City of Pitt Meadows
OFFICE OF THE MAYOR

Re: CP Logistics Park: Vancouver – City of Pitt Meadows’ Assessment of CP’s Environmental Effects Evaluation and Select Technical Studies

The purpose of this letter is to provide the City of Pitt Meadows’ (City) response to CP’s Environmental Effects Evaluation (EEE), and select technical studies for the proposed CP Logistics Park: Vancouver project (Logistics Park, Proposed Project).

Figure 2-1: Traffic Volumes for Existing Conditions (2020)

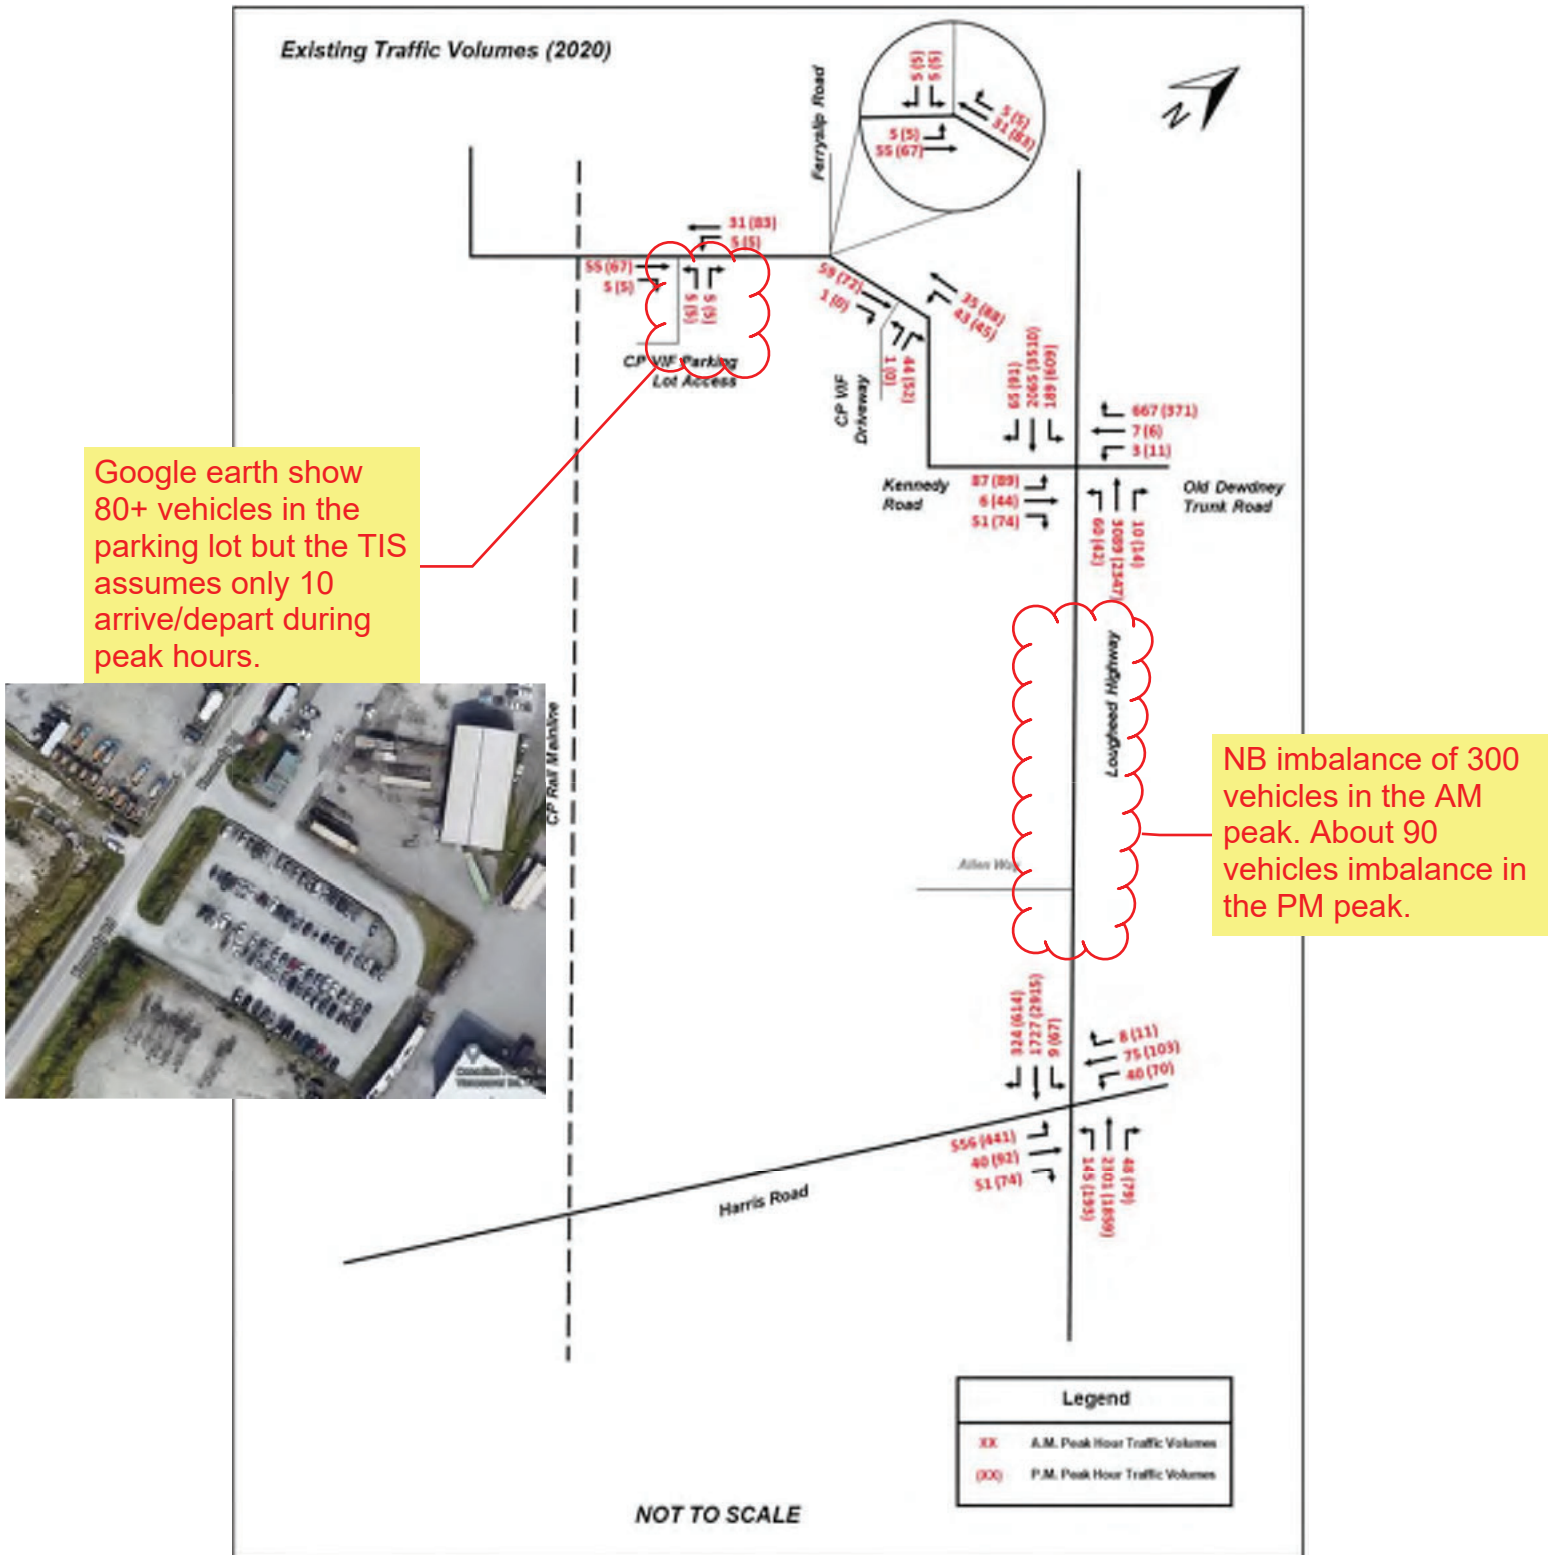
Need to note that traffic counts represent throughput, and not necessarily demand. Where demand exceeds capacity, queues start to form.

Figure 3-10: 2025 Background Conditions Traffic Operation during the A.M. peak hour

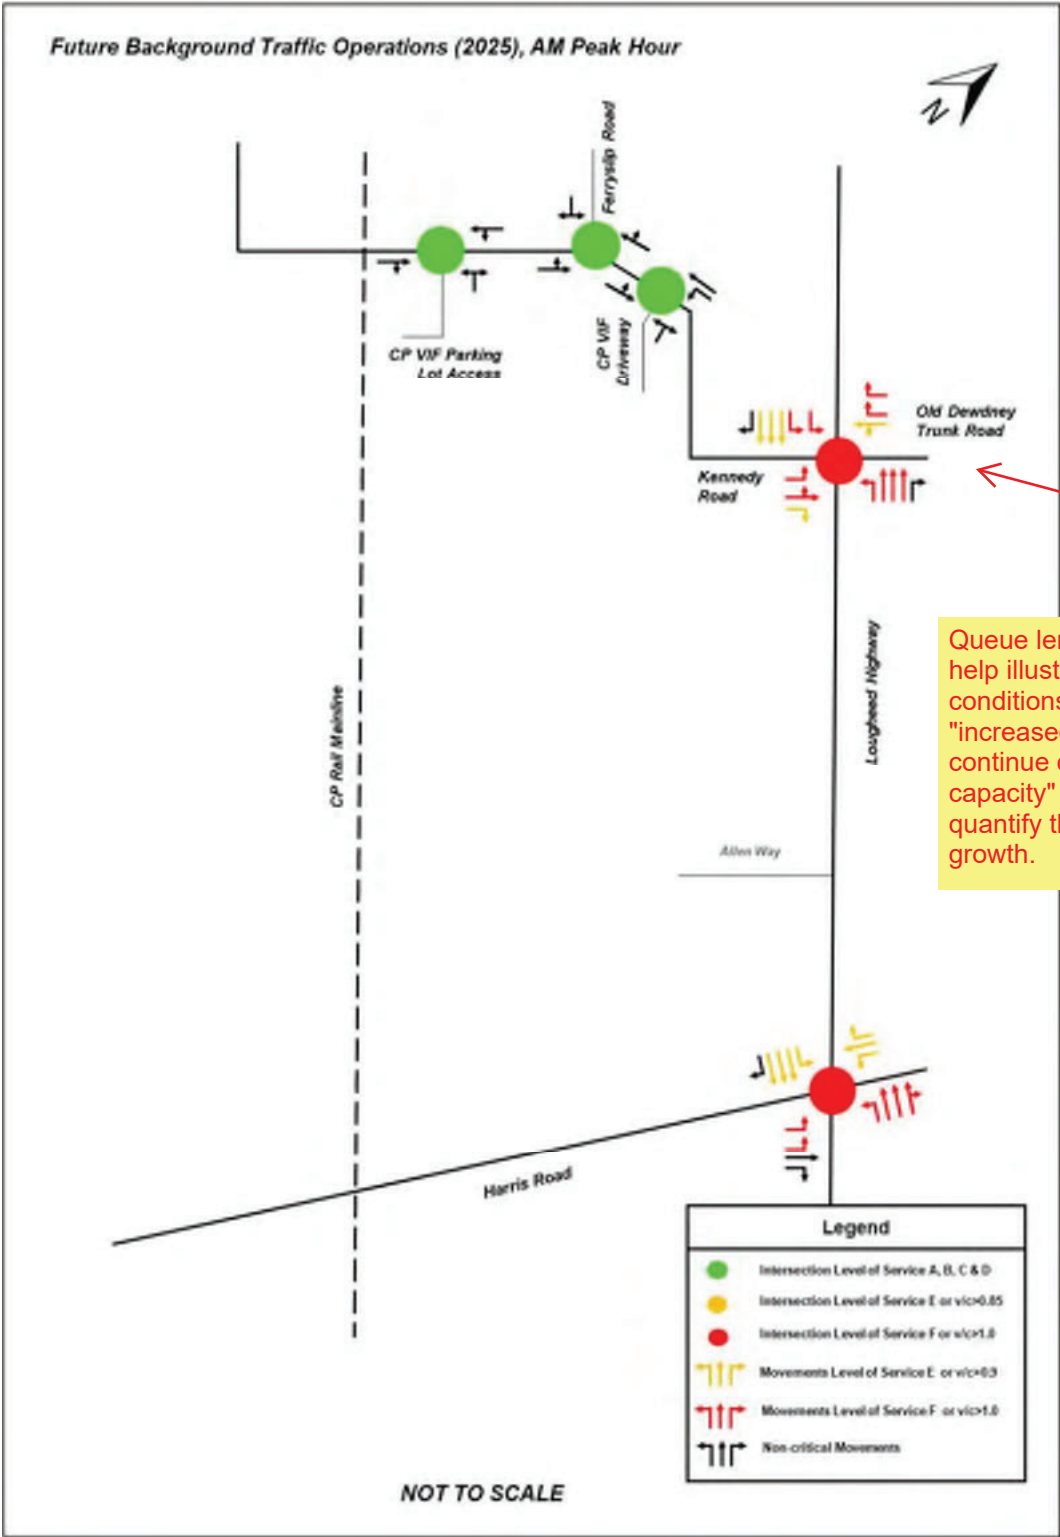
39	59	40	3.1.2 Site Preload Program Year (2025)	Figure 3-10: 2026 Background Conditions Traffic Operation during the A.M. peak hour	Queue lengths would help illustrate traffic conditions here. Saying "increased delays and continue operating over capacity" doesn't help quantify the impact of growth.	1
40	62	43	3.1.3 Full Build-Out Year (2030)	Figure 3-12: Traffic Volumes for Future Background Conditions (2030)	The parking lot access has been removed, likely because of CP's assumption that the Kennedy Road O/P would be complete by 2030. However, a sensitivity analysis was also run without the O/P. A volume figure for this scenario should be included.	2
41	62	43	3.1.3 Full Build-Out Year (2030)	Figure 3-12: Traffic Volumes for Future Background Conditions (2030)	More information is needed regarding the traffic re-distribution that was done. In 2025 there were 87vph SB during the PM peak travelling towards the rail crossing. In 2030 there are only 46vph. 51vph turn right at Ferryslip Rd.	2

Figure 3-16: 2040 Background Conditions Traffic Operation during the A.M. peak hour

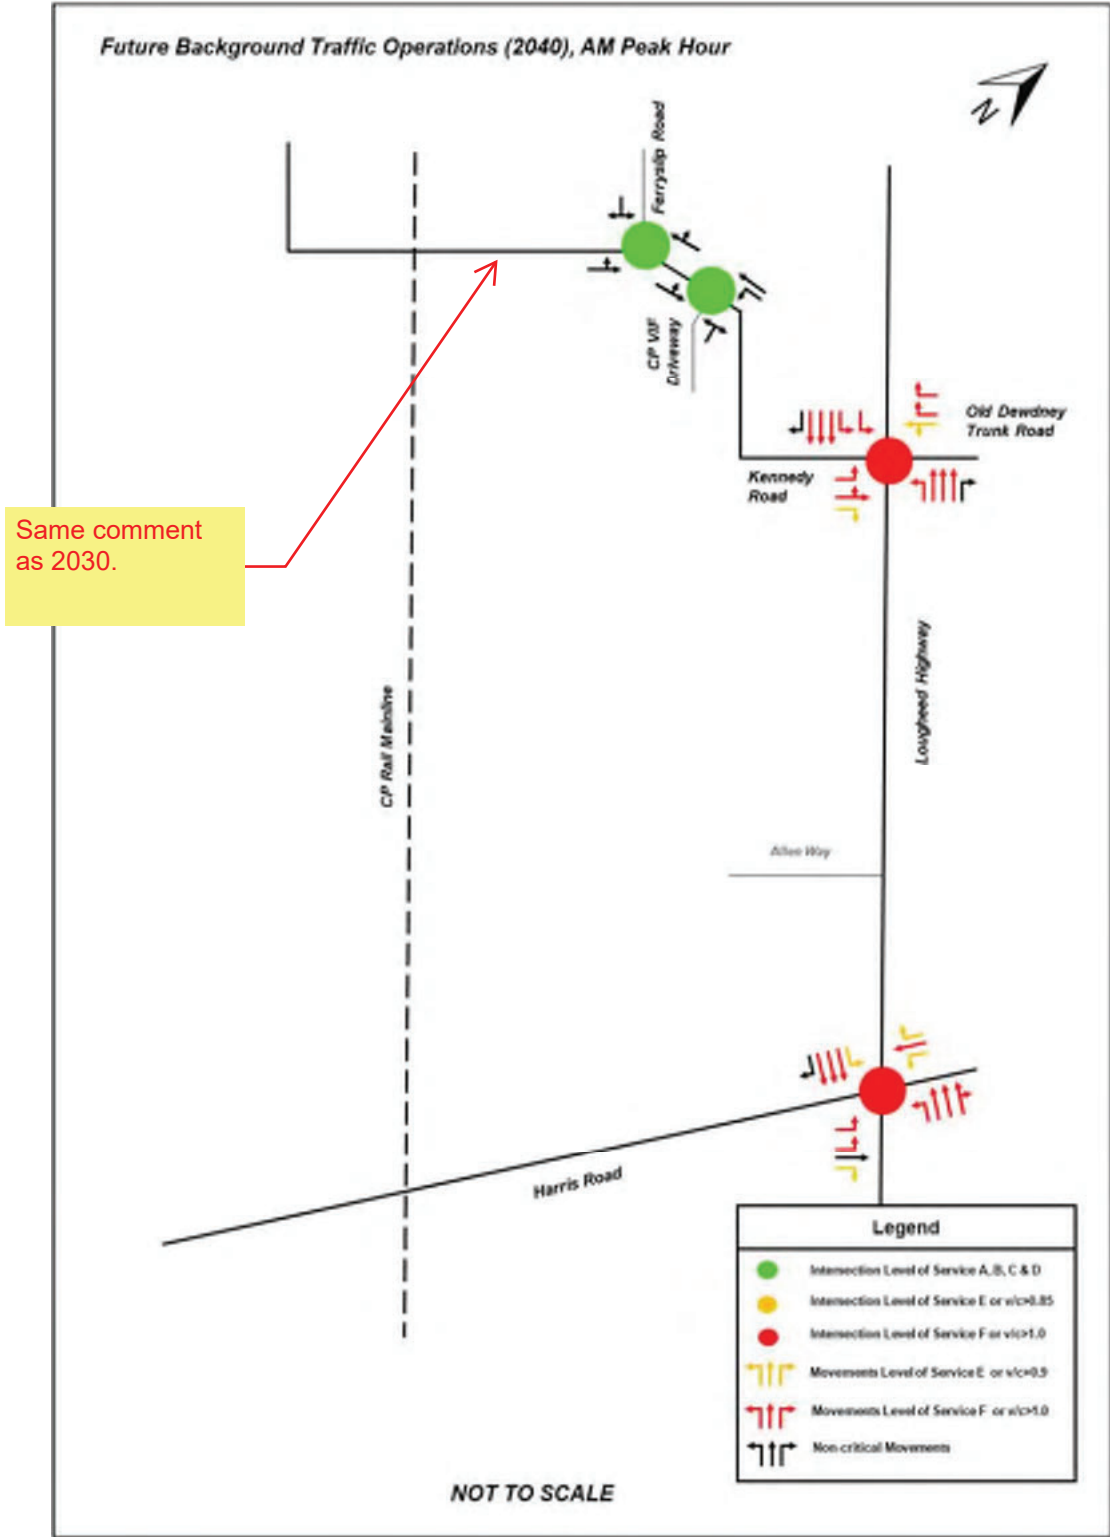
47	71	52	3.1.3 Full Build-Out Year (2030)	Figure 3-16: 3040 Background Conditions Traffic Operations during the A.M. peak hour	Same comment as 2030.	2
48	72	53	3.1.3 Full Build-Out Year (2030)	Figure 3-17: 3040 Background Conditions Traffic Operations during the P.M. peak hour	Same comment as 2030.	2
49	73	54	3.1.5.1 Site Preload Program Year (2025)		These are the same assumptions as the 2020 existing conditions. However, information from the Vancouver Fraser Port Authority suggests that by 2030, total daily train activity at Kennedy Road (i.e. the time that vehicles are blocked by a crossing) will triple. This will impact the assessment of queue lengths for future horizon years. There will be more crossing events, which could be longer in duration and more closely spaced. Increase in train activity should be accounted for in the TIS.	1

Figure 3-18: Kennedy Road Rail Crossing Queue Lengths under Background Conditions (2025) for a 5-minute rail event duration

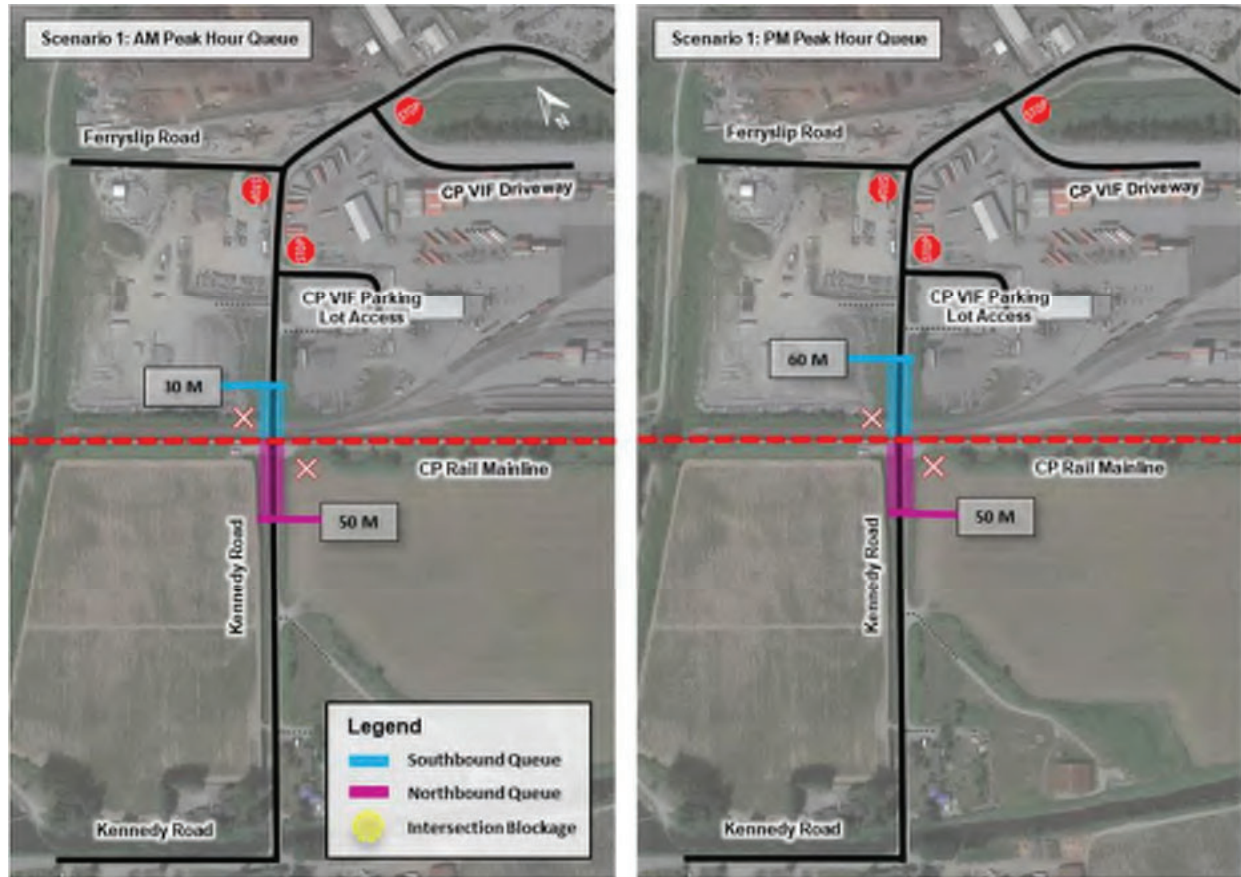
These are the same assumptions as the 2020 existing conditions. However, information from the Vancouver Fraser Port Authority suggests that by 2030, total daily train activity at Kennedy Road (i.e. the time that vehicles are blocked by a crossing) will triple. This will impact the assessment of queue lengths for future horizon years. There will be more crossing events, which could be longer in duration and more closely spaced. Increase in train activity should be accounted for in the TIS.

Figure 6-1: Access intersections to the CPLPV

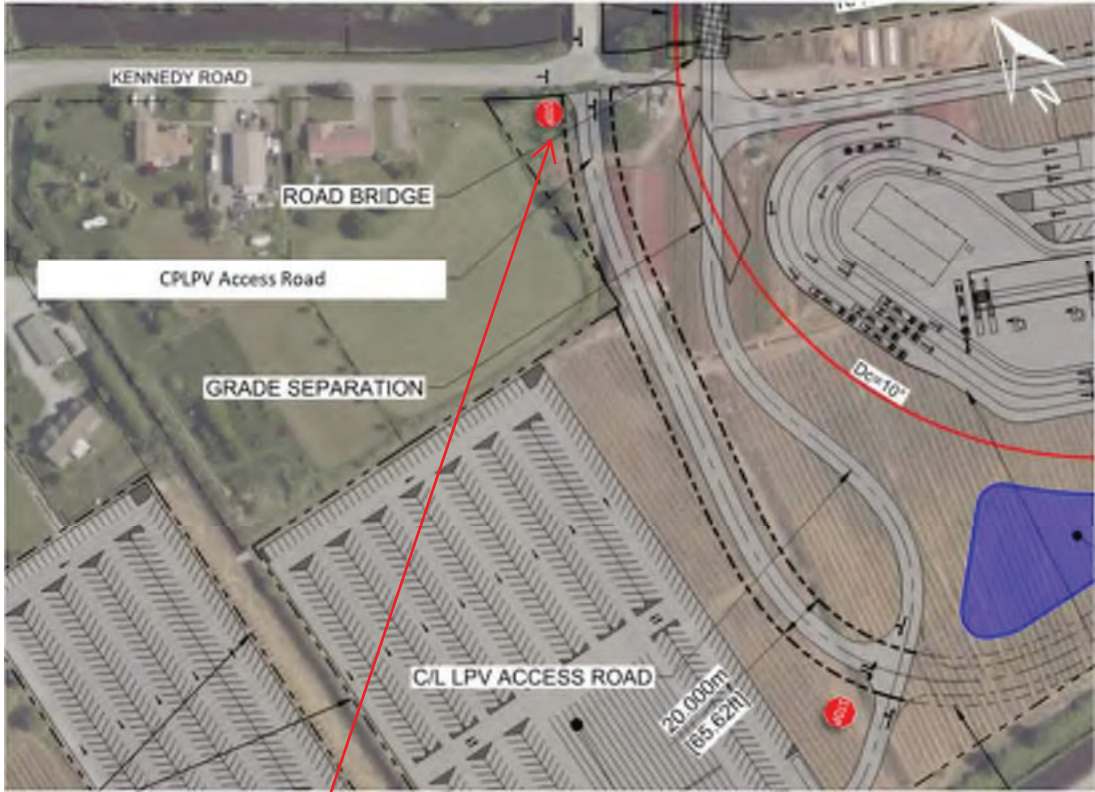
64	100	81	6. Site-Generated Traffic	Figure 6-1: Access intersections to the CPLPV	This is currently a free flow movement for EB Kennedy Road. Adding a stop control will add delays here.	2
65	102	83	6.1.1 Trip Generation		This seems too low since the port and railways have defined operating hours.	3
66	102	83	6.1.1 Trip Generation		Is this based on rail schedules or something else?	3
67	103	84	6.1.1 Trip Generation	Table 6-3: AM and PM Peak Hour Truck Trips Summary	Is this the combined 2-way volume (i.e. inbound + outbound) or is it meant to show 8 inbound and 8 outbound? The 2-way daily agricultural trips were shown to be 372, distributed evenly across 24 hours. That would equal approximately 16 2-way trips during each peak hour.	3
68	105	86	6.2.1 Trip Generation		How many stalls will be provided? Helps understand the potential in/out volumes during peak hours. <i>Comment attached to highlighted text that reads:</i> Employee parking will be provided within the facility	3

How will this be accommodated? Figure 6-1 doesn't show the connector alignment.
